# TECHNICAL INFORMATION

- Subject** ▶ Change of Switch Lever and Compression Spring 4
- For Models** ▶ 9523NB, 9523NBH, 9524NB, 9525NB, 9526NB, 9526NBH, 9527NB, 9528NB
- Country** ▶ All countries
- Description** ▶ Switch Lever and Compression Spring 4 have been changed for quick repairing as shown below.

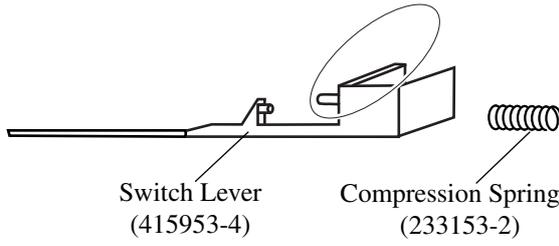
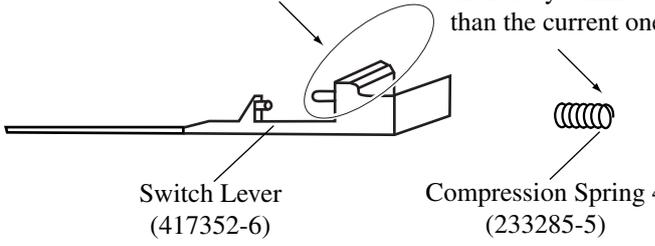
▶ Current	▶ New
 <p style="text-align: center;">Switch Lever (415953-4)      Compression Spring 4 (233153-2)</p>	<p style="text-align: left; margin-left: 20px;">The Shape changed here.</p>  <p style="text-align: right; margin-right: 20px;">The new spring is shorter by 3 mm than the current one.</p> <p style="text-align: center;">Switch Lever (417352-6)      Compression Spring 4 (233285-5)</p>

Item No.	Current part		Q'ty	I/C	New part		Q'ty	Note
019	Switch Lever 415953-4		1	No	Switch Lever 417352-6		1	Interchangeable as a set
022	Compression Spring 4 233153-2		1	No	Compression Spring 4 233285-5		1
